Product Change Notice (PCN)

PCN Number: **PCN-0454705R-01**

Product(s) Affected: **UJ2-BV-1-TH**

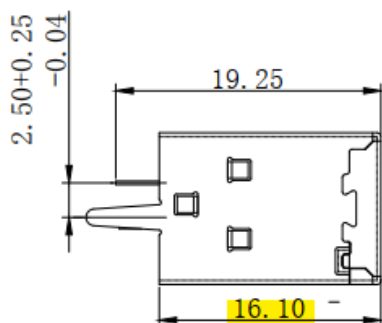
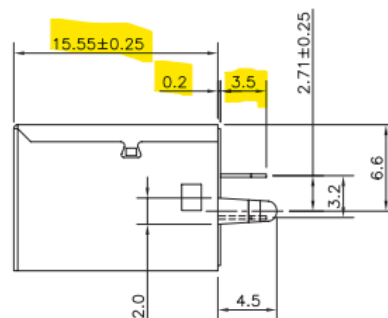
Description of Change: **New Factory Location. Product optimized for improved production yield and board fit. Minor housing difference. Longer legs, taller body, and shorter pin lengths. The leg shape has more exaggerated crimp for a more secure board fit. PCB footprint is equivalent in function and layout. Operating temp range improved. Current capacity increased from 1 amp to 1.5 amp. Insertion force decreased from 35N to 30N. Additional changes in measurements listed.**
